## MEMORANDUM

Foundation Investigation Report  
for  
Proposed Crossing of Bear Brook  
Tributaries by Highway #417  
Twp. Gloucester - Co. Carleton  
District No. 9 (Ottawa)

Foundation Investigation Report  
for  
Proposed Crossing of Bear Brook  
Tributaries by Highway #417  
Twp. Gloucester - Co. Carleton  
District No.9 (Ottawa)  
W.J. 68-F-57    --    W.P. 34-66-05

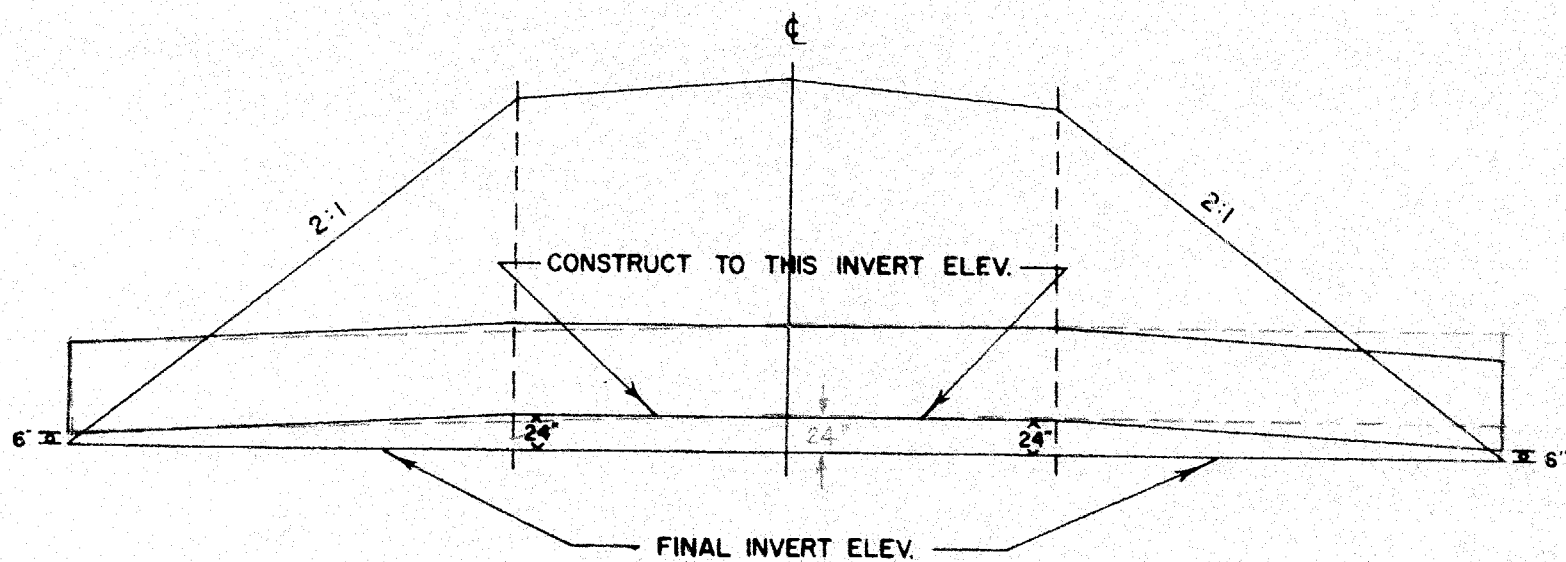
Your proposed culvert construction at Bearbrook tributary (Sta. 431+00 E.B.L.) has been discussed with the Foundation Section who have recommended that the culvert be constructed to the invert elevations indicated on the attached sketch. This recommendation is based on the predicted 15 year settlement under the core of the embankment and proportionately less under the sloped portion.

Note:- Advised Hunter Meyer in Kingston Region by telephone on Jan 27th 69 about the details of camber for the proposed. Recommended camber is shown ~~on red~~ red on the enclosed sketch.

APPROVED		SHEET No. 3-266	W.P. No. 34-66-15
BRIDGE ENGINEER	CONTRACT No.		
DESIGN W.L.L. CHECK	DRAWING D.H.B. CHECK		
DATE OCT / 65	LOADING H 520-4	DRAWING No.	D-6584-P

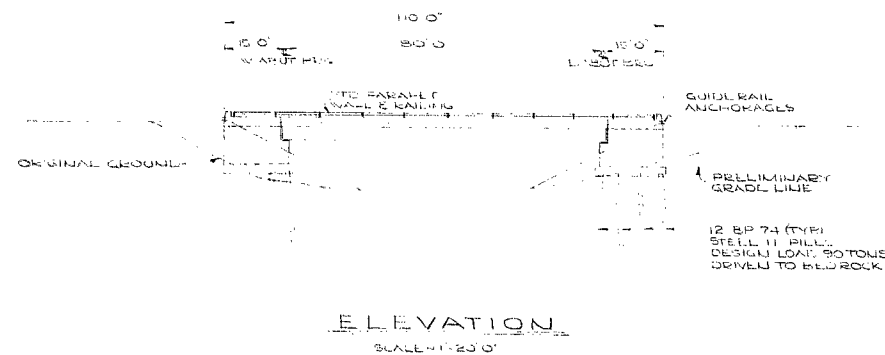
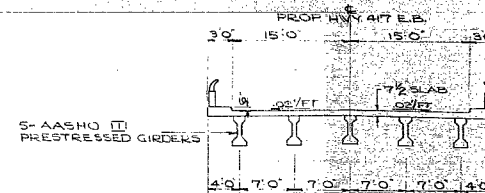
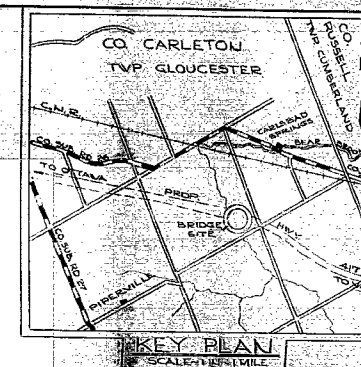
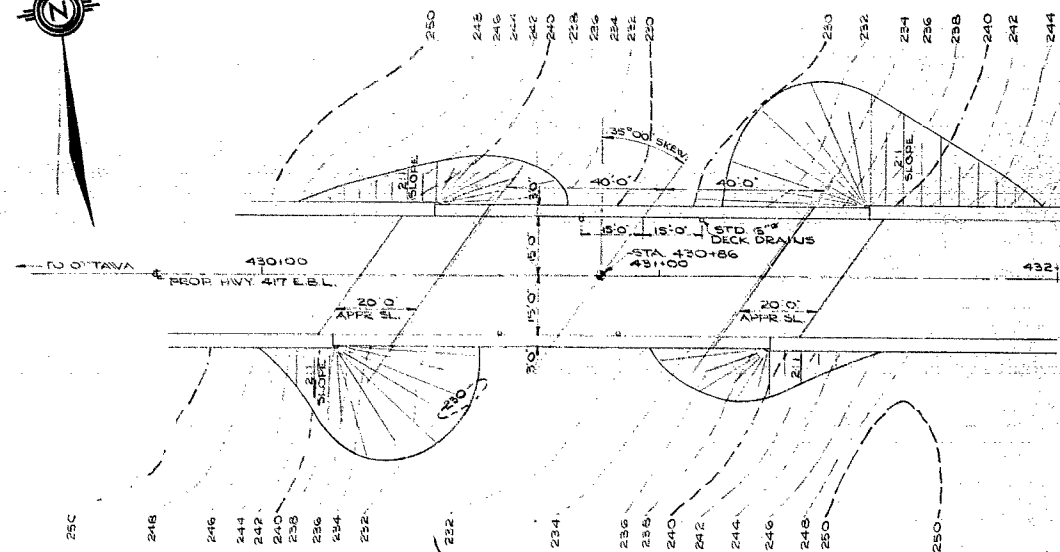
*No comment  
M. Levata  
7th Nov/68*
